#### **ADDENDUM #3**

PROJECT: CODESTACK ACADEMY

REF. # : ARCH PROJ. No. 2023-04

DATE: 27 November 2024

UT2

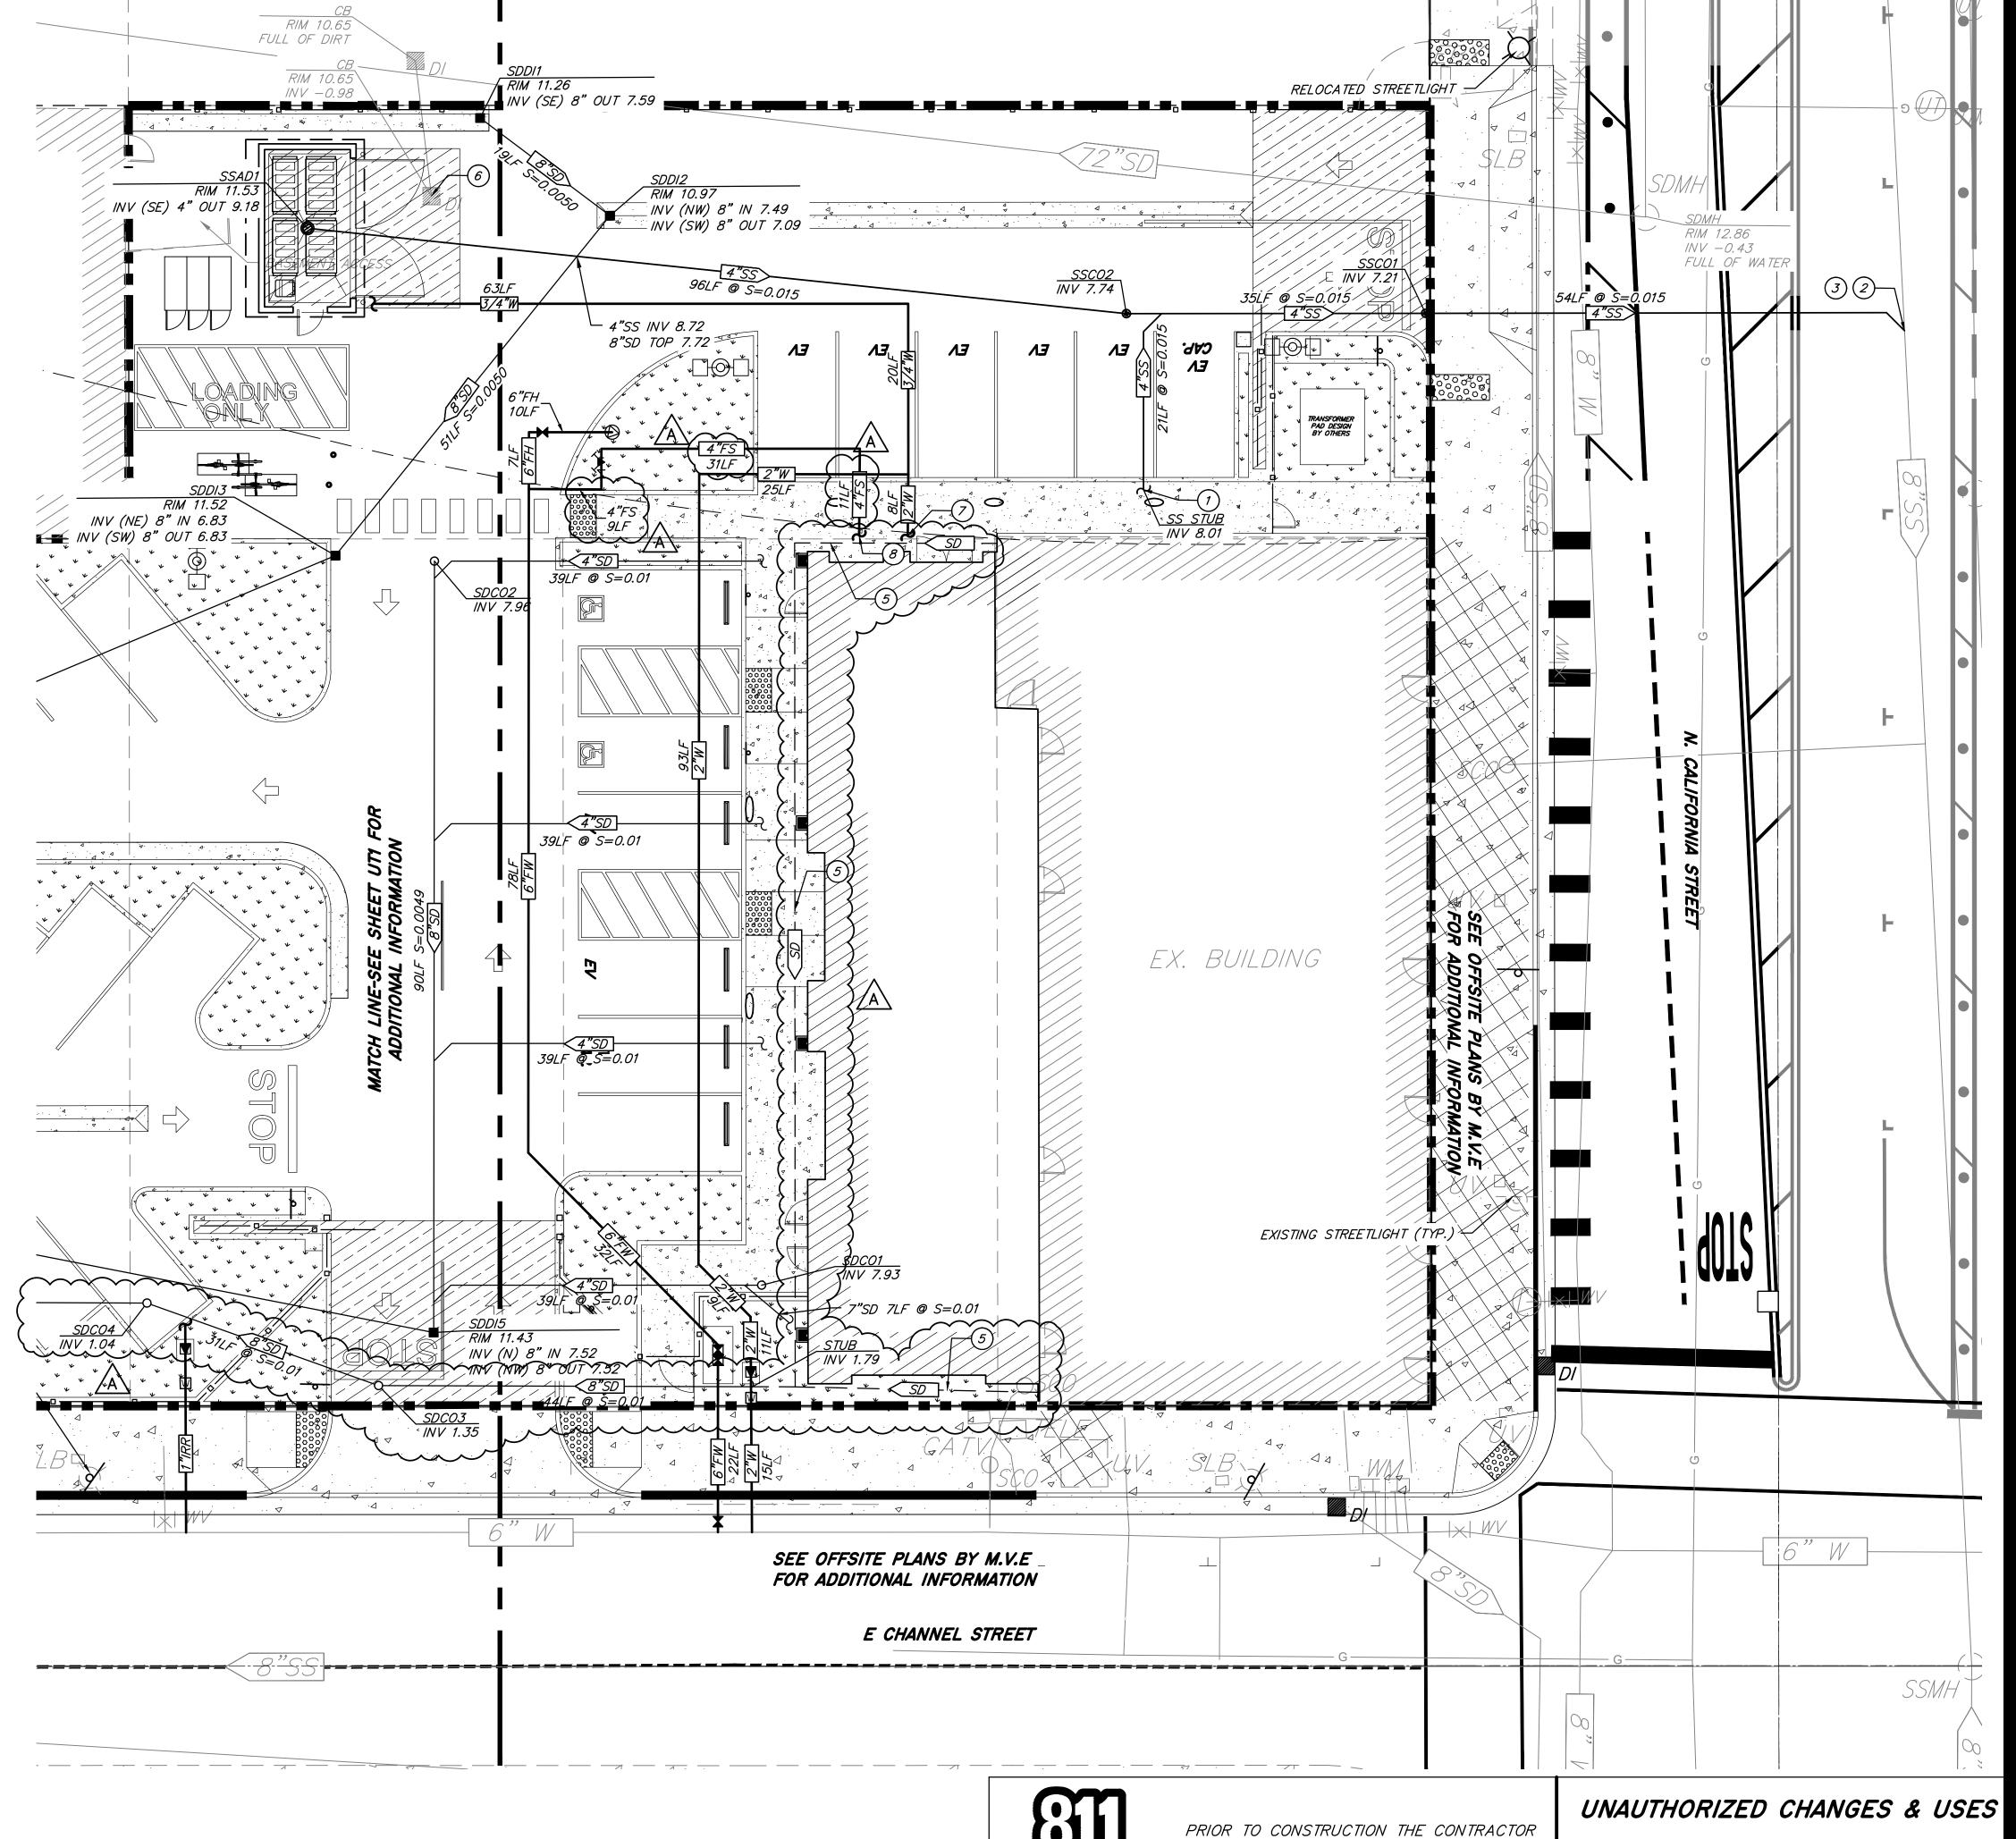
#### ITEM 2 Sheets UT1, UT2:

- Water Service Sizing Coordination with Plumbing and Landscape
- Add/ Identify drainage route for Building Perimeter drain (Sheet UT1)

M1.0

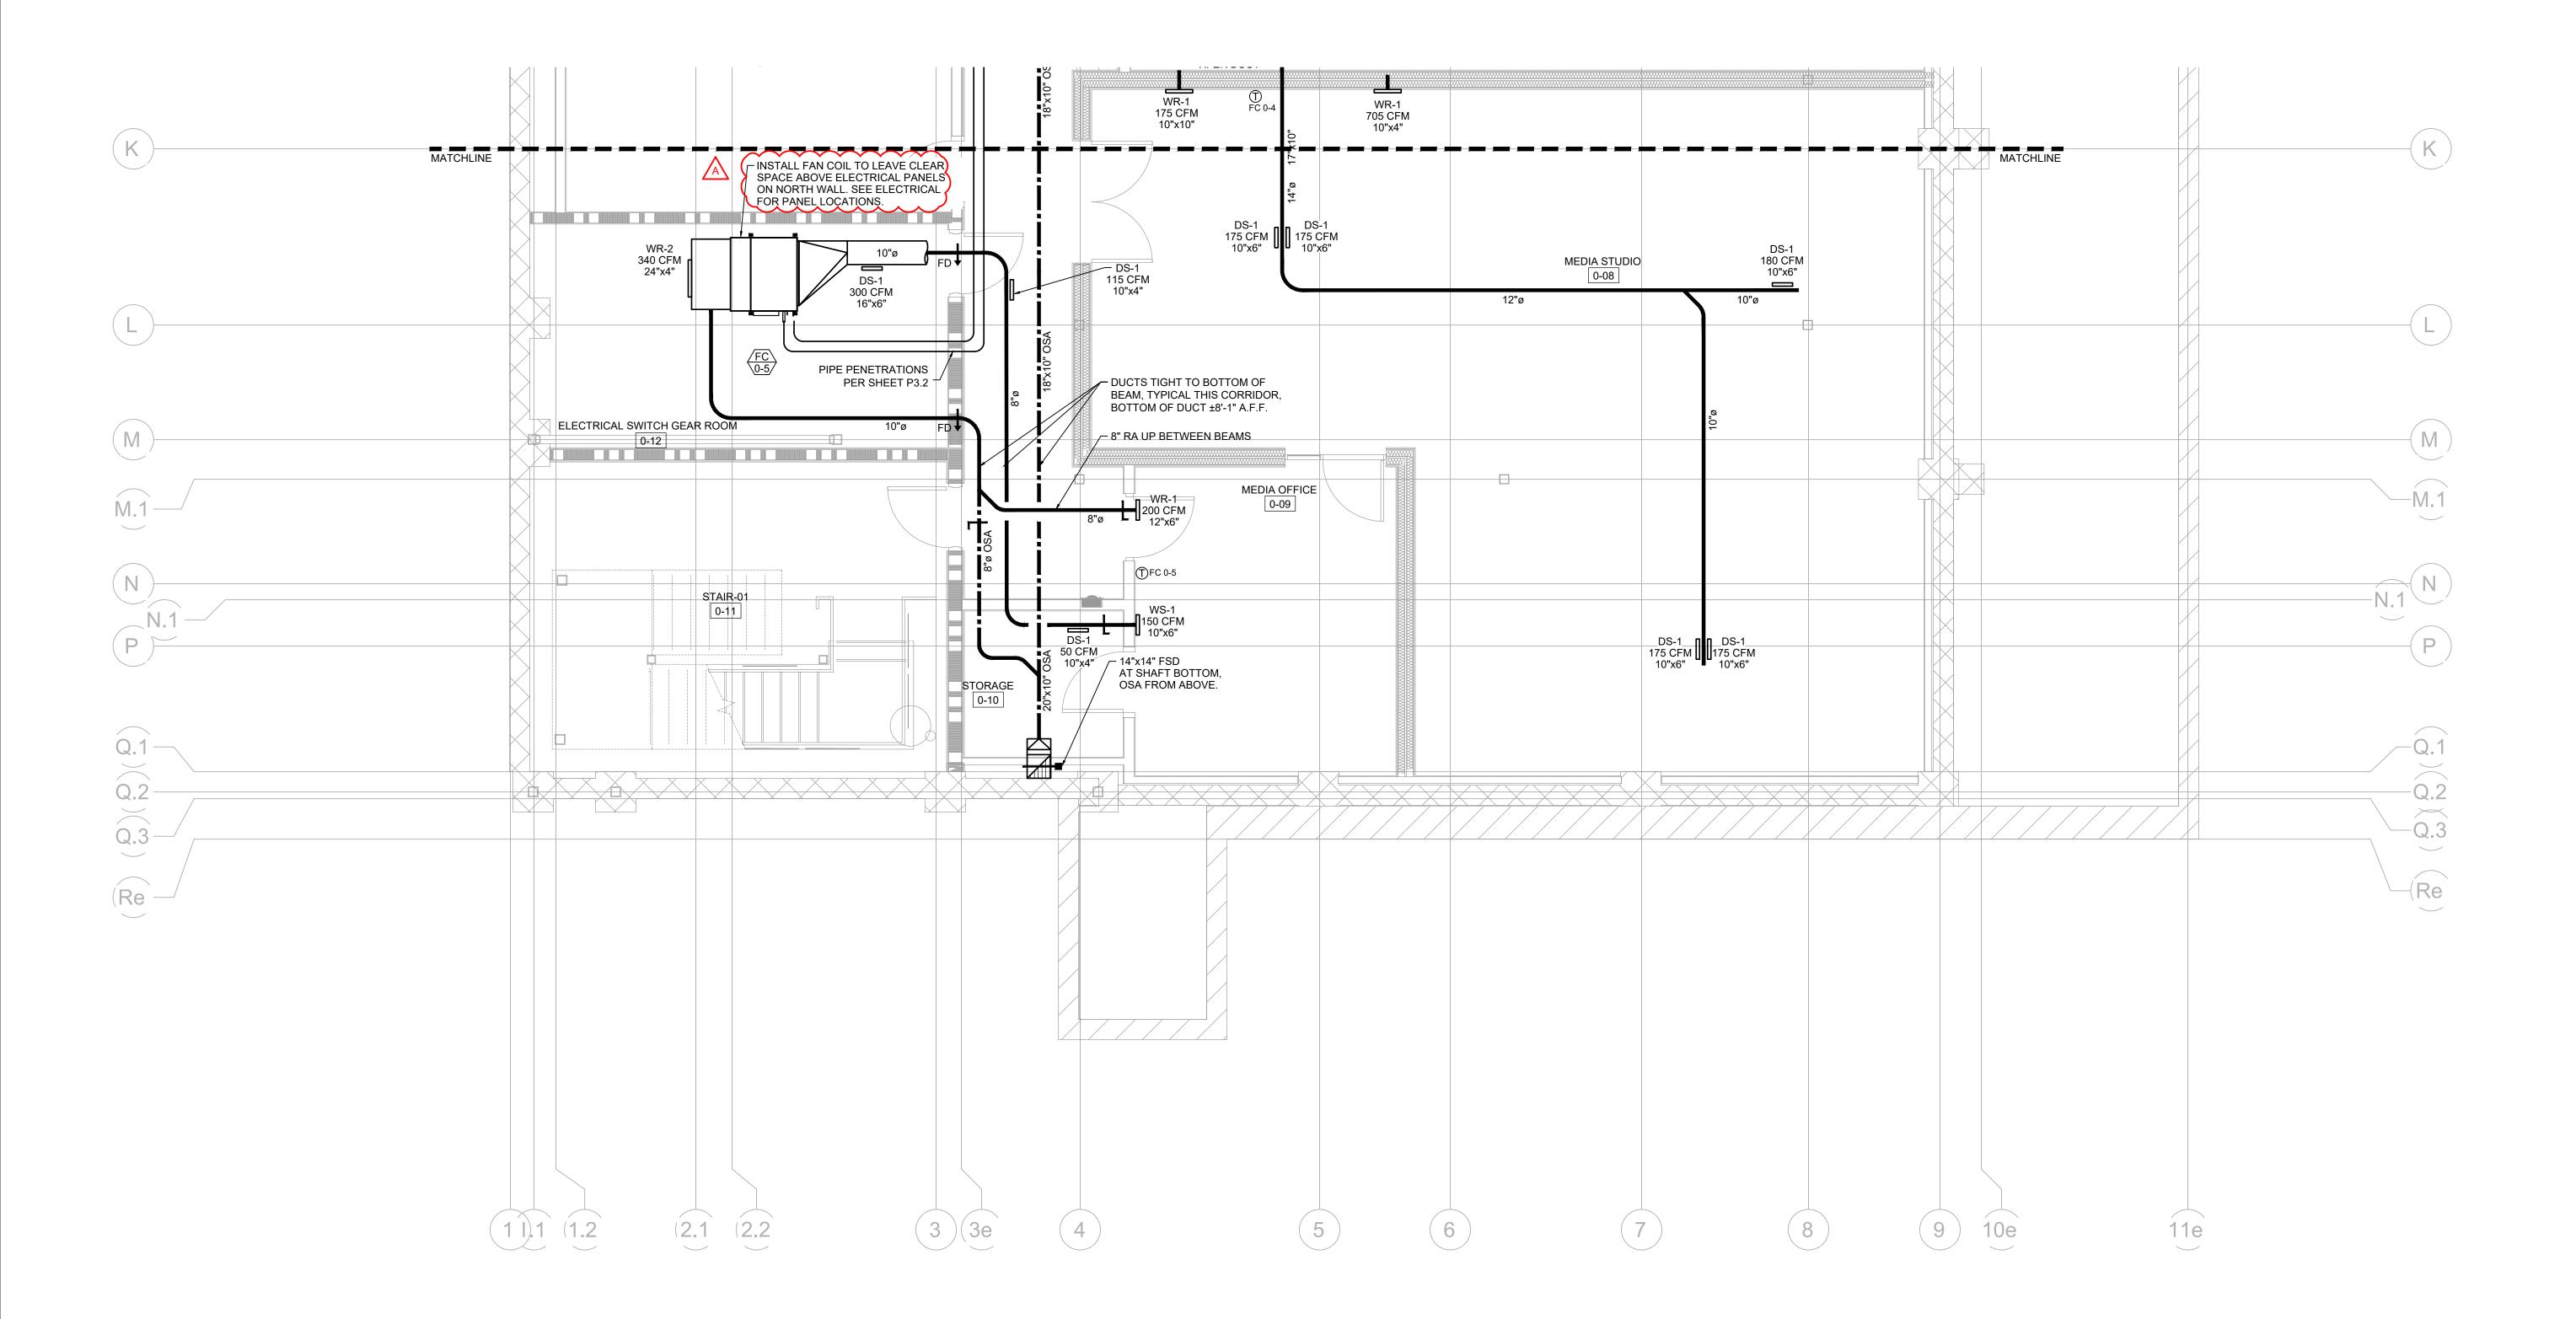
#### ITEM 1 SHEET M1.0

Revisions to vent location due to coffee reconfiguration.

M1.1

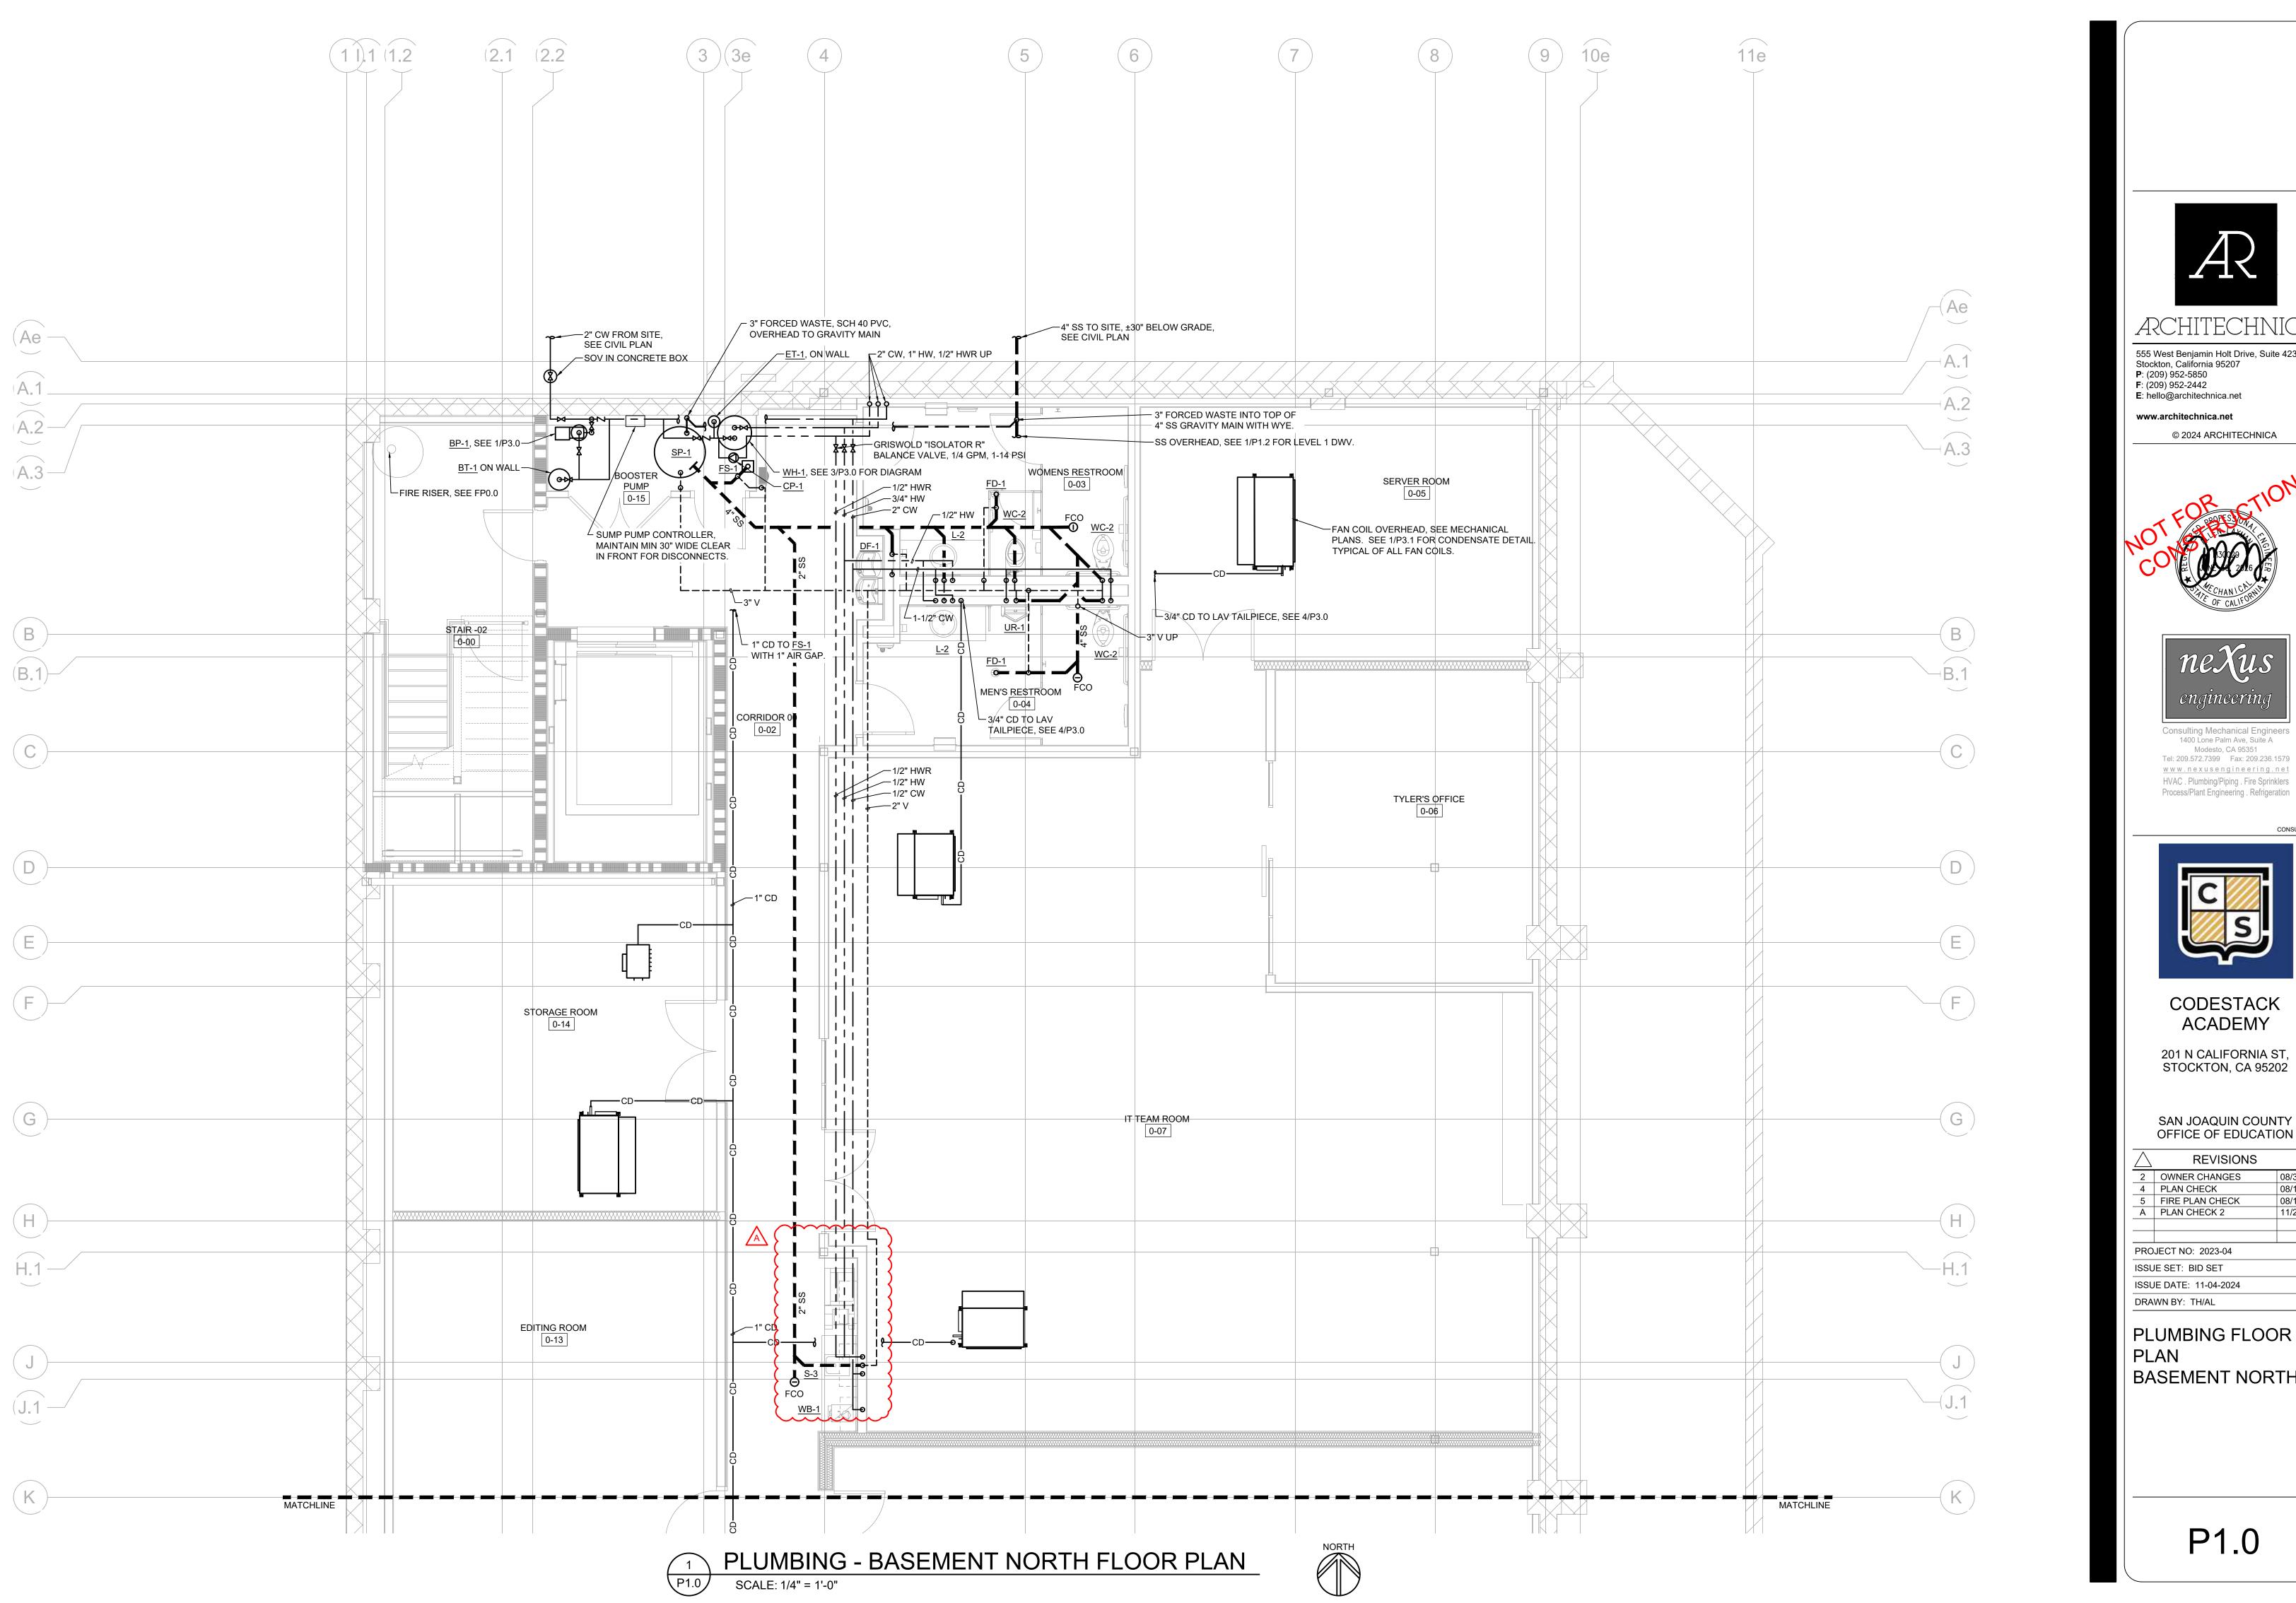
#### ITEM 2 SHEET M1.1

Revisions to equipment locations in electrical switchgear room per plancheck comments.
